USB Type-C ENGINEERING CHANGE NOTICE

Title: C to A cable electrical requirement

Applied to: USB Type-C Specification Release 1.1, April 3, 2015

From Figure 3-55

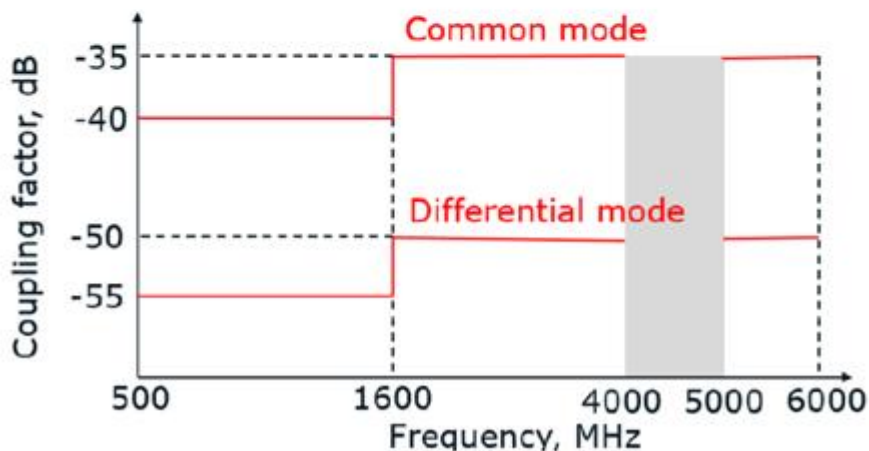
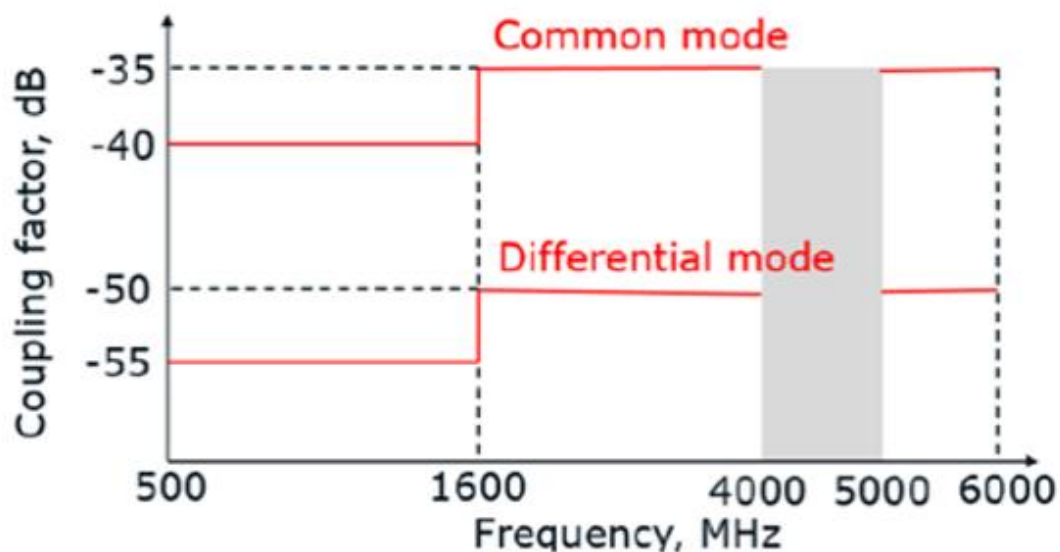
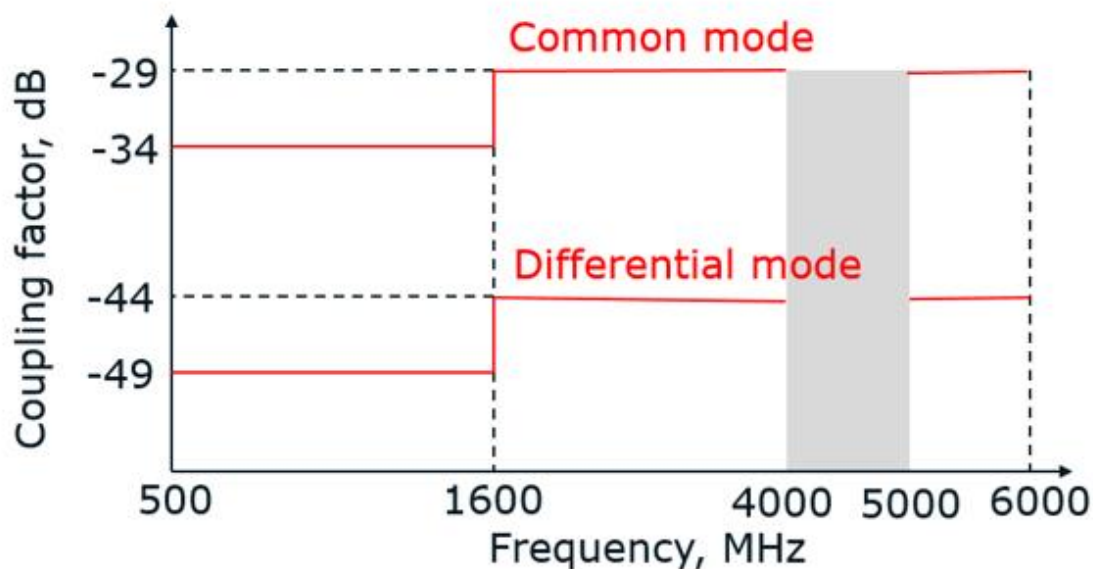
Test data of type C to type A cable indicated the shielding effectiveness requirement is too tight in the specification. The proposed changes are to relax the electrical criteria of the type-C to type A cable without significant impact on the system.
--

(a). Section 3.7.6, Page 90

To Figure 3-55:
